SUBJECT: Chase Bank at 19080 Willamette Drive

Project Details

Preap-PA-11-16-Chase Bank

L-Series Prototype - Brick

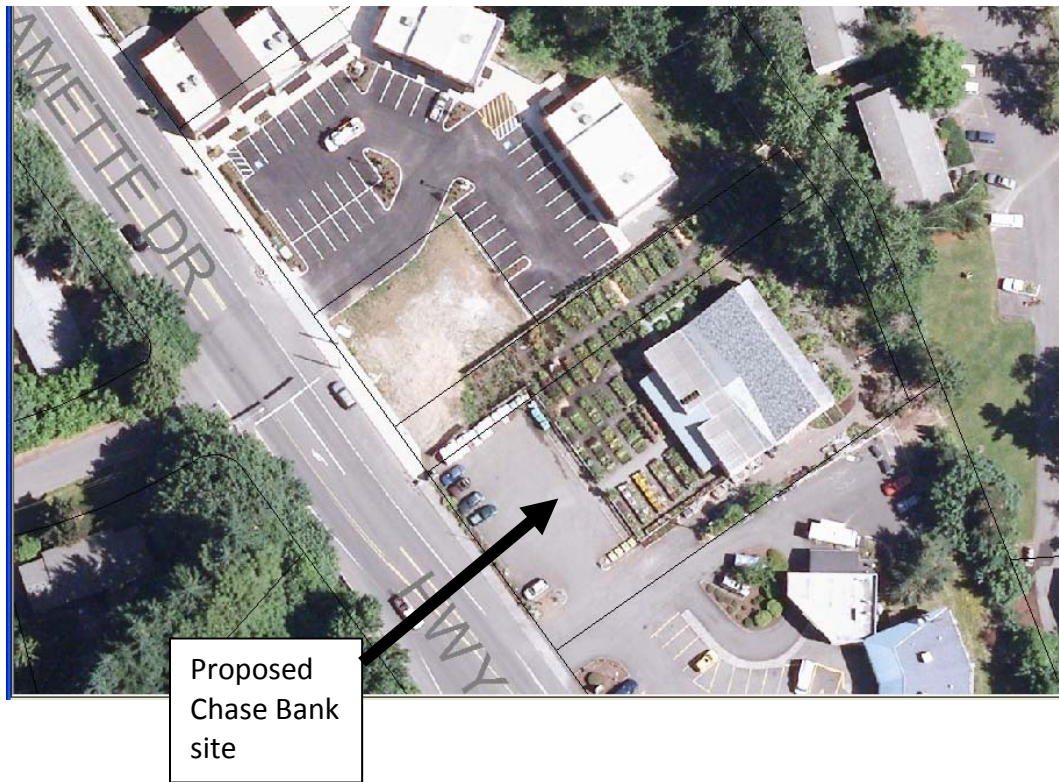
By the notation on the plans (L-Series Prototype –Brick) it seems that the design is one of a number that could have been chosen. Be that as it may, this design is a single story structure. As seen from Willamette Drive the front elevation is broken into three parts with the central entry way section capped with a hipped/pyramidal roof. (The roof positively mirrors the design

of the Starbucks up the street (see photo below)) The entry way makes good use of glass with a flat protective awning and transom windows above the awning as well. Above the transom windows is an area for the main sign. The brick clad columns that are on each side of the entryway section breaks up the horizontal plane effectively. The vertical plane is broken into three elements by using different building materials including brick cladding at eye level. The Community Development Code (CDC) offers the following comments and standards:

CDC 55.100(B)(7) requires that all businesses have at least one main entry onto the street side. The front large well defined entryway on Willamette Drive meets the criterion. The transom looks good. Extending the awning to provide more rain protection (6-8 feet) is needed.

The single story building looks to be clad in drivet from grade to two feet above grade (bulkhead), then brick from about two feet to nine feet followed by more drivet which is capped by a contrasting colored cornice. The use of smaller cornices that barely project from the building (or no cornices at all) is preferred rather than using the exaggerated cornices

common on so many retail or office buildings. Flat /horizontal rooflines are preferred over the dated false front/parapets and peaks.

Transparency

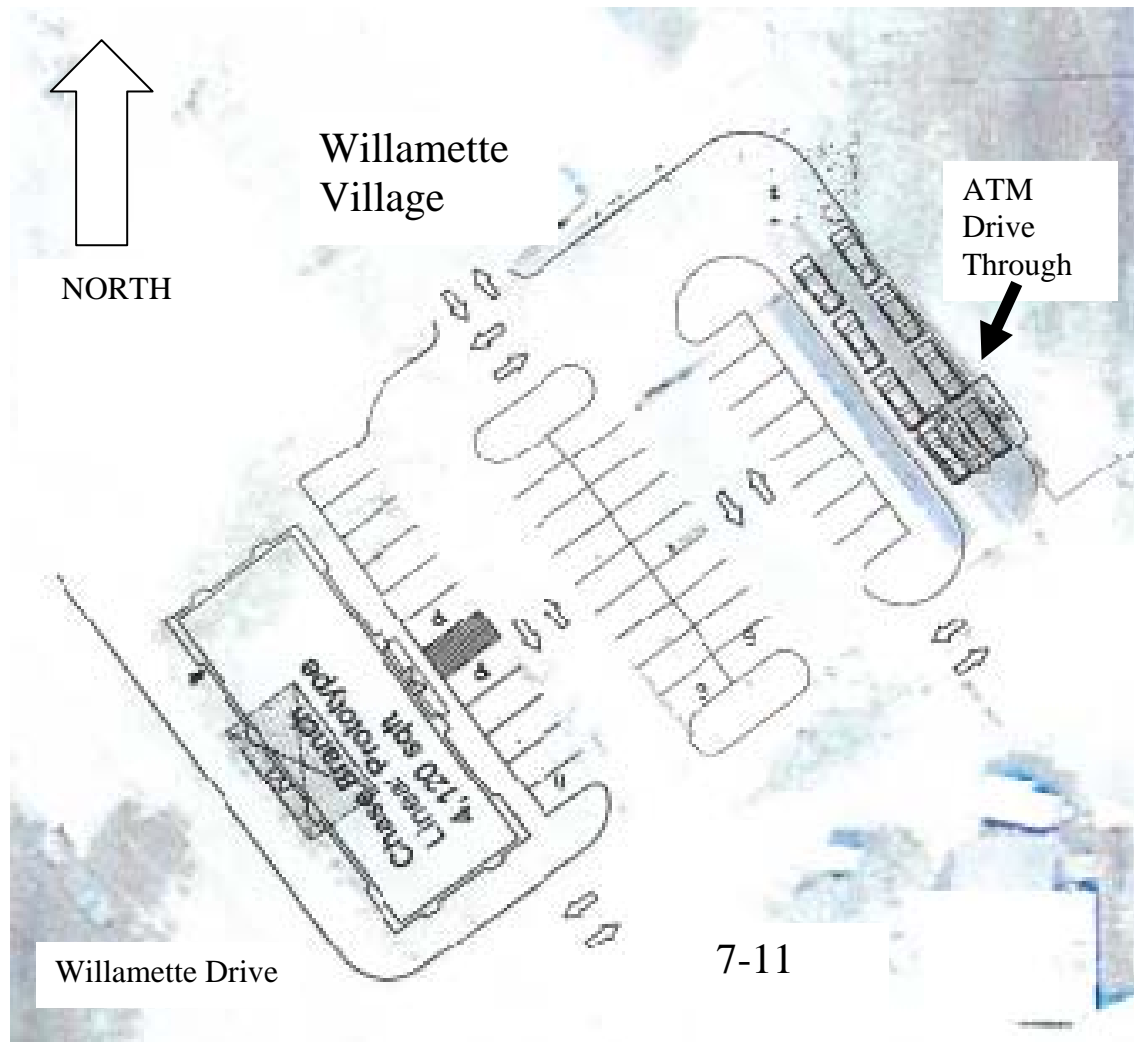
The transparency requirements of CDC 55.100(B)(6)(f) must be met. Sixty percent of the lineal frontage of the Willamette Drive elevation must have windows. At least one of the north or south facing elevations needs 30 percent transparency too. Glass must be clear and cannot be mirrored or smoked etc. The west facing or main elevation on Willamette Drive has about 53% transparency. That's good but it needs to be increased to meet the 60% standard. Both north and south facing elevation are blank. This is a problem.

The CDC allows for "transferring" window square footage. Thus it would be possible for the applicant to get credit for any surplus transparency on a re-designed front or side elevation. The applicant could apply for a variance: requesting that transparency on the rear elevation be "transferred" or credited to the front or side elevations. The applicant could strengthen the variance request by adding some acceptable kind of wall decoration, bas relief, art work etc. on those blank elevations. The applicant mentioned using a faux window with a poster inside. Staff is agreeable to looking at a drawing or photograph of how that would look but it sounds like that would still have to be attached to a variance request.
